Replacement of BPD1083 with BPD1485

Textar will harmonise the part numbers BPD1083 and BPD1485 and will only keep BPD1485.

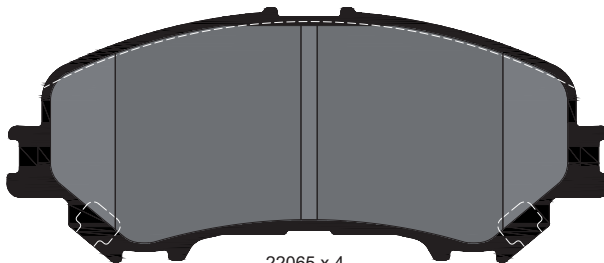
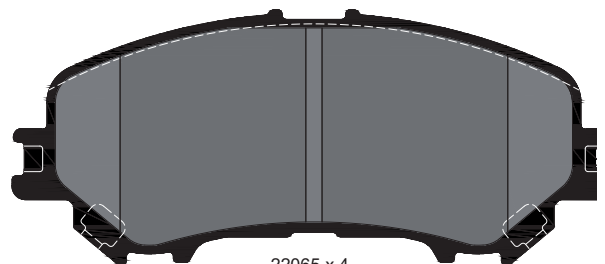
The difference between BPD1485 and BPD1083 is that BPD1485 is slightly thinner.

141.8 x 59.7 x 17.9

141.8 x 59.7 x 16.7

Given the identical outer dimensions of the brake pads we can ensure seamless assembly and operation.
